Office Action Summary	Application No.	Applicant(s)
	10/591,041	KLEIN, VOLKMAR
	Examiner	Art Unit
	ATIF H. CHAUDRY	4156

DETAILED ACTION

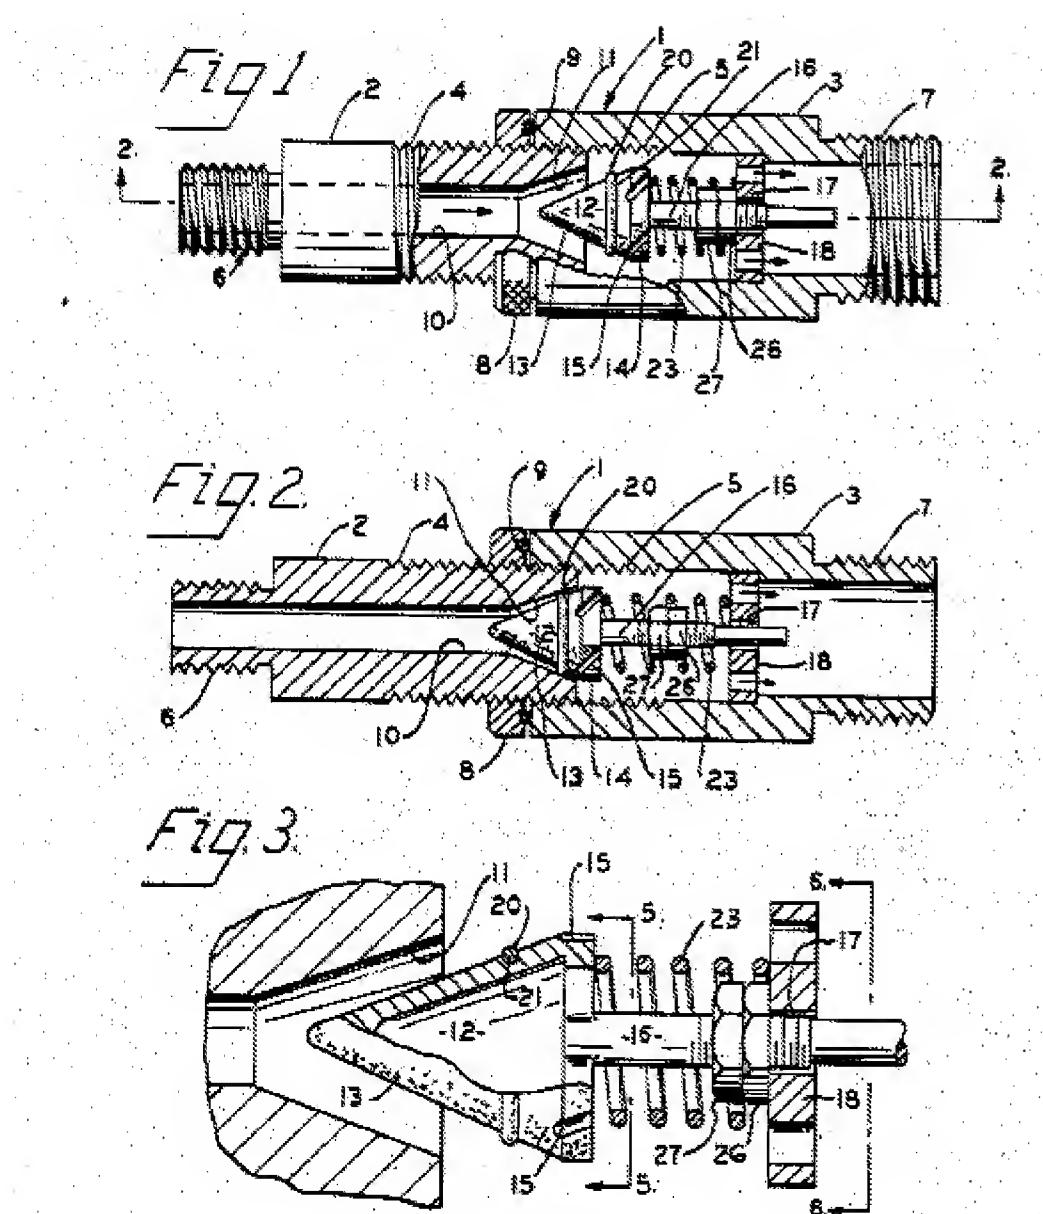
3. Regarding claim 1, Hengesbach discloses (fig 1) a valve housing 1 with an interior fluid passage along its axis, a seat element 2 with valve seat 11a detent element 16 movable against a spring 23 wherein the valve seat can be adjusted axially to adjust the closing force of the spring.

4. Regarding claim 2, Hengesbach discloses a displacement device 9 actuatable from exterior of the valve for axial adjustment of the valve seat.
5. Regarding claim 3, Hengesbach discloses seat element 2 which is axially movable in the housing 1 and therefore can be described as a piston and is coaxial with the interior passage.
6. Regarding claim 8 a guide element 17 with fluid passages 18 which guide the valve head 12 in axial displacement.

Fig.1

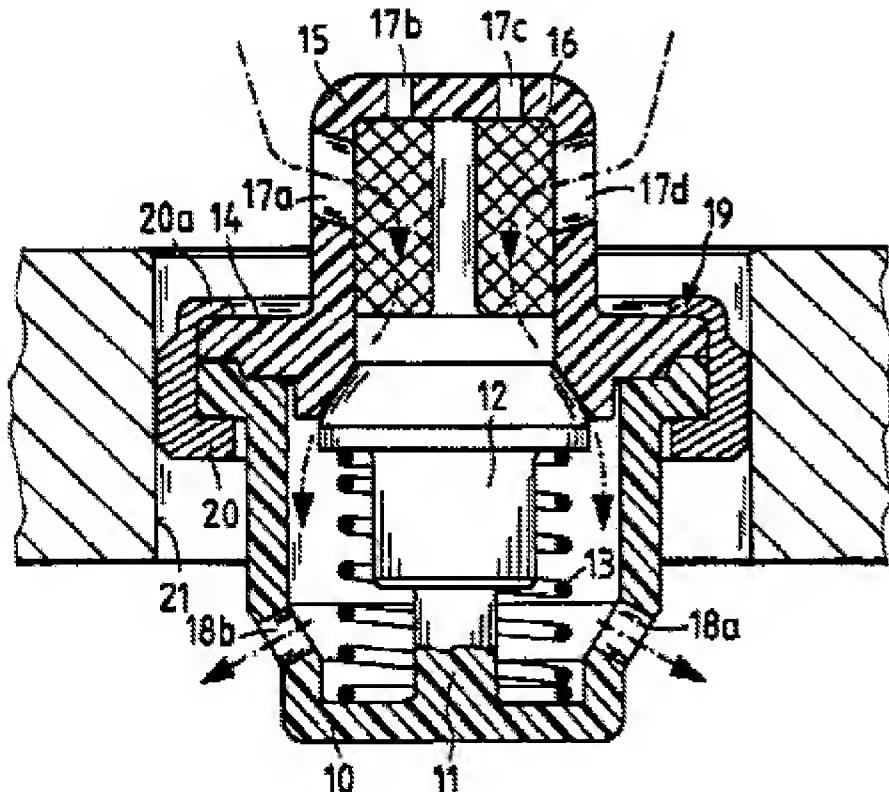
9. Regarding claim 9, Hengesbach discloses a guide pin 16 which is attached to the valve head therefore is not the valve head is not moveable with respect to the guide pin. Orth (fig 1) teaches a guide pin 11 which is fixed and the valve body 12 slides axially on the guide pin. It would have been obvious to a person of ordinary skills in the art to have substituted the valve guide arrangement of Hengesbach with that of Orth as an alternate method known in the art. The claim would have been obvious because a
